TES PATENT AND TRADEMARK OFFICE UNITED STATES DEPARTMENT OF COMMERCE United States Patent and Trademark Office Address: COMMISSIONER FOR PATENTS P.O. Box 1450 Alexandra, Virginia 22313-1450 www.cspto.gov CONFIRMATION NO. FIRST NAMED INVENTOR ATTORNEY DOCKET NO. 5313 07/29/2003 Calvin L. Cagle CAG-001 EXAMINER 7590 03/09/2005 Jeffrey K. Seto ADAMS, GREGORY W 617 Tinkerbell Rd. ART UNIT PAPER NUMBER Chapel Hill, NC 27517 3652

·								
	ation No. Applicant(s)								
(F <sub>2</sub> 0/62)	9,214 CAGLE, CALVIN L.								
Office Action Summery MAY 0 2 2005 Exami									
Srego	ry W. Adams 3652

## **DETAILED ACTION**

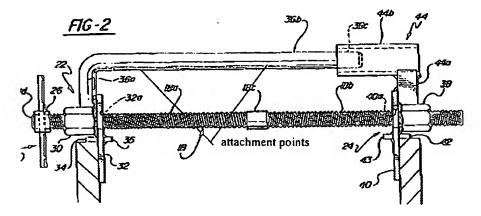
- 5. With respect to claim 3 & 8, referring to FIGS. 1-2 Boyden et al. disclose a brace further comprises attachment points as shown below. It is noted that a lifting force would be applied through these attachment points and could be applied manually.
